Improving Current Carrying Capacity for the Smart Sensor Simulator 2

SSS2 Power Wire Addition Page 2 of 3

Figure 2: Completed connection for the Safe 12V net.

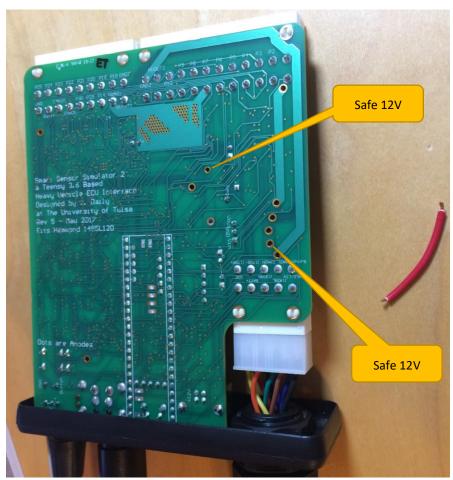
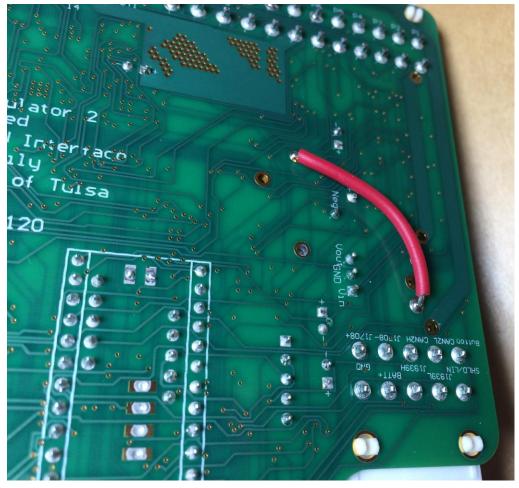
Some Engine Control Units, like Caterillar ADEM3 modules, draw a large amount of current on startup. It has been discovered that this current is large enough to overheat one thin copper trace on the printed circuit board of the SSS2 revision 5 hardware. This overheating can lead to premature failure.

Place an 18 or 20-gauge jumper wire to bridge the connection between one side of the thin copper to the other, which provides a high current path and alleviates the thermal stress of the trace. Photographs of the solution are shown in the following figures.

Figure 4: The lime green highlight show the thin trace that can prematurely fail.

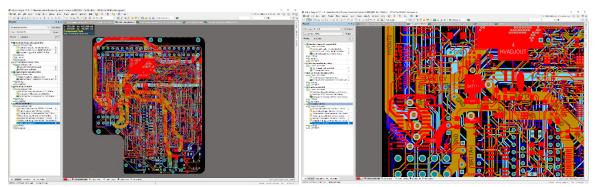
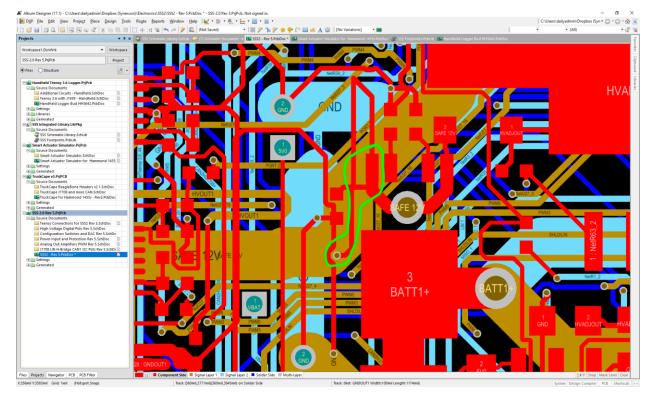
The issue was located in the Altium CAD files as shown in the following screenshots:

Synercon Technologies recommends that all owners of the SSS2 Rev 5 hardware have this upgrade performed. Please contact sales@synercontechnologies.com to arrange for the modification.
